**GM SERVICE AND PARTS OPERATIONS
DCS1574
URGENT - DISTRIBUTE IMMEDIATELY**

SUBJECT: Product Safety Recall 06026A
Power Steering Hose Separation

MODELS: 2006 Buick Lucerne with a V8 Engine (RPO LD8)
2006 Cadillac DTS

File In Section: Product Recalls
Bulletin No.: 06026A
Date: April 2006

1683880

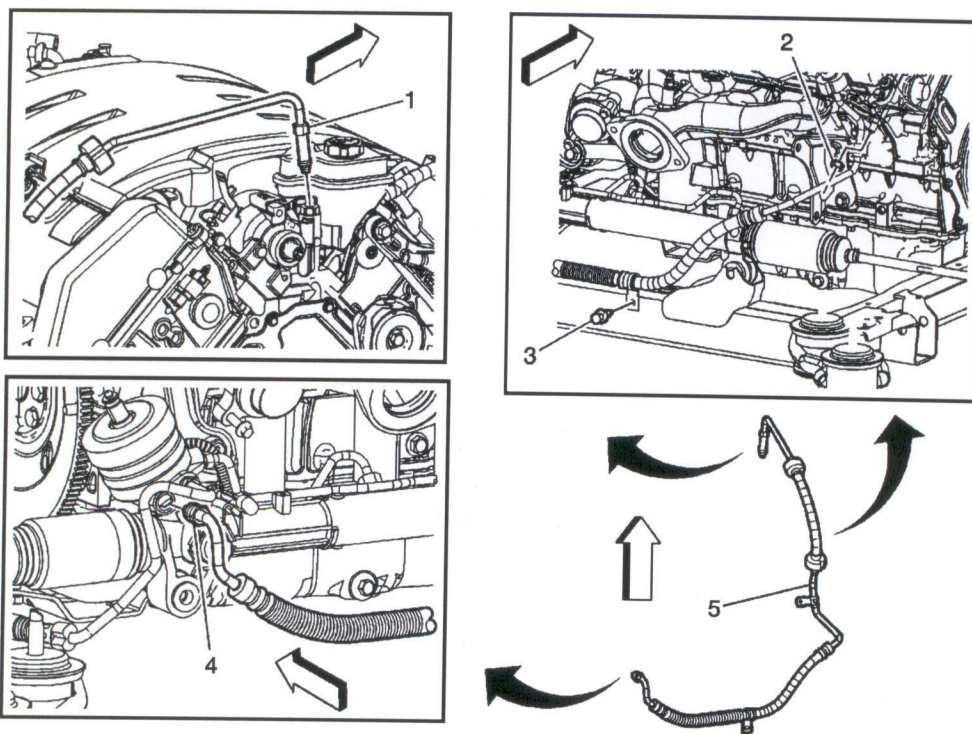
Today, we are releasing bulletin 06026A in which the service procedure and labor time in this bulletin have been revised. Please review the changes immediately. Discard all copies of bulletin 06026, issued March 2006.

THE SERVICE PROCEDURE AND LABOR TIME IN THIS BULLETIN HAVE BEEN REVISED. PLEASE REVIEW THE CHANGES IMMEDIATELY. DISCARD ALL COPIES OF BULLETIN 06026, ISSUED MARCH 2006.

1. Install fender covers.
2. Install a drain pan under the vehicle.
3. Disconnect the power steering pressure hose (1) from the power steering pump.
4. Raise and support the vehicle. Refer to *Lifting and Jacking the Vehicle* in SI.
5. Support the frame (cradle) with an adjustable jack stand.
6. Remove the four rear frame (cradle) bolts.
7. Lower the rear frame (cradle) no more than 76.2 mm (3 in).
8. Remove the nut (2) retaining the power steering hose bracket at the cylinder head.

9. Disconnect the push pin (3) connecting the power steering bracket to the frame.
10. Disconnect the power steering hose (4) from the steering gear.
11. Drain and remove the power steering pressure hose from the vehicle.
12. Install the new power steering pressure hose to the vehicle.
 - 12.1 Connect the power steering hose (4) to the steering gear.

Tighten the power steering pressure hose to the power steering gear to 27 N·m (20 lb ft).

Tighten the power steering pressure hose bracket retaining nut to 9 N·m (80 lb in).

Tighten the four frame (cradle) bolts to 181 N·m (133 lb ft).

Tighten the power steering pressure hose to the power steering pump to 27 N·m (20 lb ft).
